CITY OF ST. LOUIS
**PLANNING & URBAN
 DESIGN AGENCY**
 CULTURAL RESOURCES OFFICE
 FRANCIS G. SLAY, Mayor

DATE: January 25, 2016
 ADDRESS: 625 N. Euclid Avenue
 ITEM: New Application to install one illuminated blade sign
 JURISDICTION: Central West End Certified Local Historic District — Ward 18
 STAFF: Andrea Gagen, Preservation Planner, Cultural Resources Office

DATE: January 25, 2016
 ADDRESSES: 2115-2131 Hickory Street
 ITEM: Preliminary Review: demolition of an industrial building
 JURISDICTION: Lafayette Square Local Historic District; Lafayette Square National Register Historic District, Preservation Review District — Ward 6
 STAFF: Betsy Bradley, Cultural Resources Office

DATE: January 25, 2016
 ADDRESS: 6105-23 Delmar Boulevard
 ITEM: Preliminary Review of new building
 JURISDICTION: Skinker-DeBaliviere Certified Local Historic District — Ward 28
 STAFF: Betsy Bradley, Cultural Resources Office

RENDERING OF PROPOSED SIGN ON BUILDING

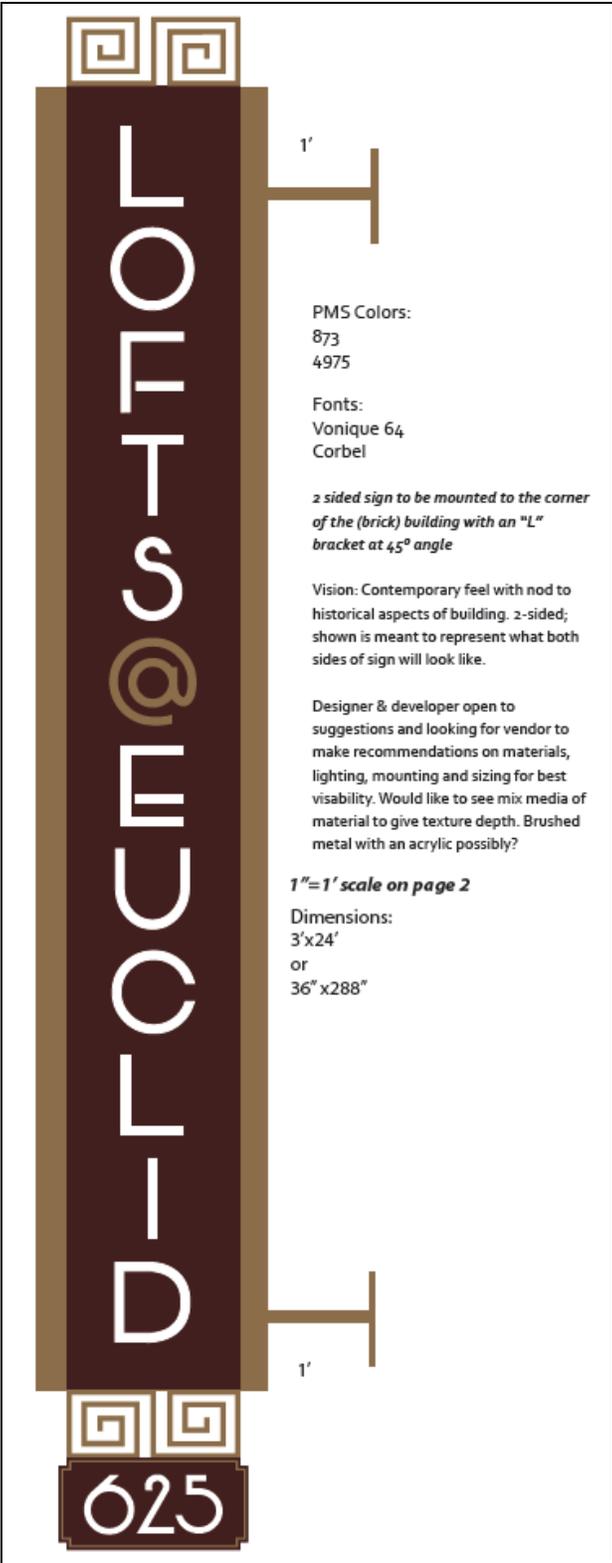
Does not comply. The proposed sign would be mounted above the second story window sill.

- 625 N. Euclid is located in the Central West End Local Historic District.
- The owner proposes to install a 3-foot by 24-foot internally illuminated projecting sign.
- The proposed sign would be mounted above the second story window sill, and the sign would not meet the Central West End Historic District standards.

- Yet the scale of the building and the sign are compatible and as the sign is identifying the entire building, and not a storefront business, its location above the second story window sill may be appropriate in this case.
- Historically, tall projecting signs like this were a feature of multi-story urban buildings.

Based on these preliminary findings, the Cultural Resources Office recommends that the Preservation Board approve the sign application, if it finds that the historic type of sign that identifies the entire building is appropriate in the proposed location.

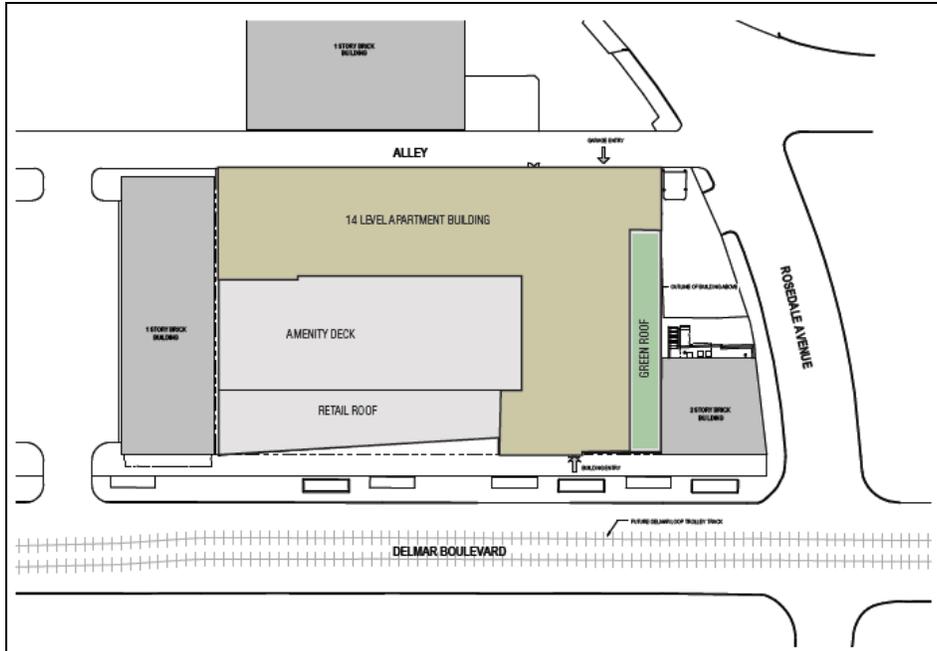
Does not comply. The 14-story building has the form of a podium with an L-shaped tower rising above it. The tower meets the street at the east end of the site and is set back at the rear of the podium at the north side. The podium fronts Delmar with a three-story form dominated by a two-story storefront. The building has been massed and designed to address the disparity in heights along Delmar. Its form and location of the tallest portion of the building, echoes that of the Moonrise Hotel, the tallest building on Delmar in the district at this time, which also has an L-form.

Mostly complies. The building would fill the entire Delmar frontage, as is the pattern for commercial buildings on Delmar. Part of it would meet the consistent building line on the north side of Delmar on this block. The podium has a shallow angle that widens the sidewalk at the east end of that component.

Complies. Brick, in two dominant red-brown shades, is proposed for the majority of the exterior of the building, including its side and rear elevations. As the building is a contemporary design, secondary materials include concrete board panels as cladding on the podium and upper stories. Cast stone is proposed to clad the east end of the podium. Brick at the storefront would be two accent colors. Metal Juliet balconies and a metal canopy at the storefront level would be accent materials. The lower portion of the third-story podium wall is proposed to be a “green wall,” covered with vegetation.

Mostly complies. The articulation of the building breaks it visually into vertical bays and other elements that are of comparable scale and rhythm to those on historic buildings. Individual window opening proportions are comparable. The larger glazed wall sections are more limited than the other pattern and compatible with the contemporary design.

- The proposed building does not meet the existing historic district standards for height, which requires a nearly comparable height to adjacent historic buildings with less than a 15 percent difference. Flanking buildings are two- and three-stories in height; the tallest building on the blockfront, several parcels to the east, is the seven-story Moonrise Hotel.

- Scale, also a consideration in the historic district standards, is addressed by the complex massing of the building. The common proportions for the tower, in terms of height and width, the low-rise podium, and the mix of materials minimize the scale of the building as it would be experienced from within the historic district.

Based on the Preliminary findings, the Cultural Resources Office recommends that the Preservation Board grant preliminary approval to the design if it finds the proposed height justified by the building's location within the district, and with the stipulation that final plans and exterior materials are reviewed and approved by the Cultural Resources Office.

FRONT ELEVATION

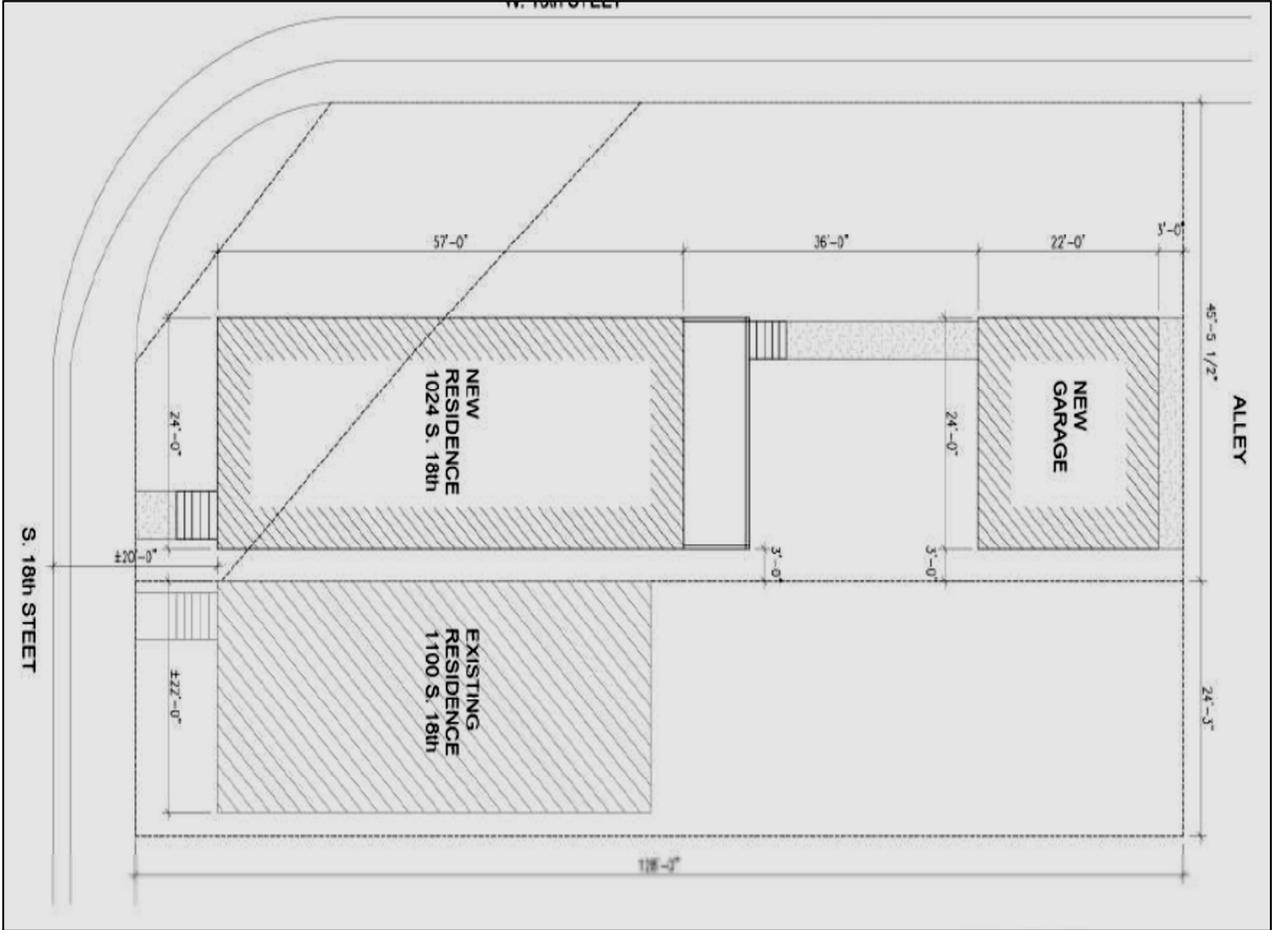
The site plan meets the standards for alignment and setback.

The massing will be tall, narrow and deep, as appropriate for a single-family house in the Square, and two stories in height, as are most of the houses on South 18th Street

The windows to be used on the façades will have arched heads: semi-circular on the first story, and segmental on the second, following the HME. The windows will be approved by the CRO as to materials, dimensions and profiles similar to those of the HME, and have the correct brick mold.

The cornice of the HME will be replicated in scale and design and profile, including a return on the sides. Additional detail and a mock-up of the proposed cornice have been submitted.

Based on the Preliminary findings, the Cultural Resources Office recommends that the Preservation Board grant preliminary approval to the design, with the stipulation that final plans and exterior materials are reviewed and approved by the Cultural Resources Office.

GOOGLE PHOTO OF WALL BEFORE DEMOLITION

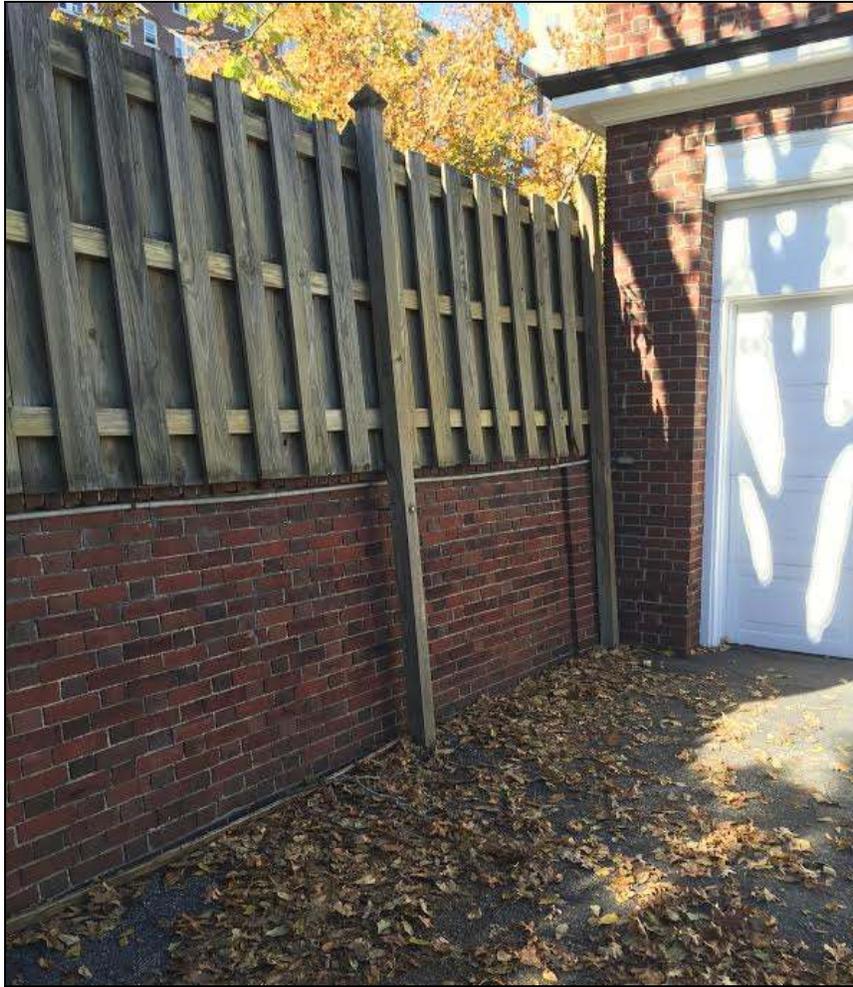
In late November, the applicant applied for a permit to remove and install a wood fence at 54 Westmoreland Place. During construction, the Cultural Resources Office received a complaint that an historic brick wall at the property was being demolished. The office issued a Stop Work Order for the project, but the wall had been removed at that point. The applicant has now applied for a permit for the demolition that occurred without a permit. The permit was not approved as the demolition does not meet the Central West Historic District standards.

Based on these preliminary findings, the Cultural Resources Office recommends that the Preservation Board uphold the Director’s denial of the application for the demolition of the wall, as it does not comply with the Central West End Local Historic District standards, and require that the historic wall be replicated.
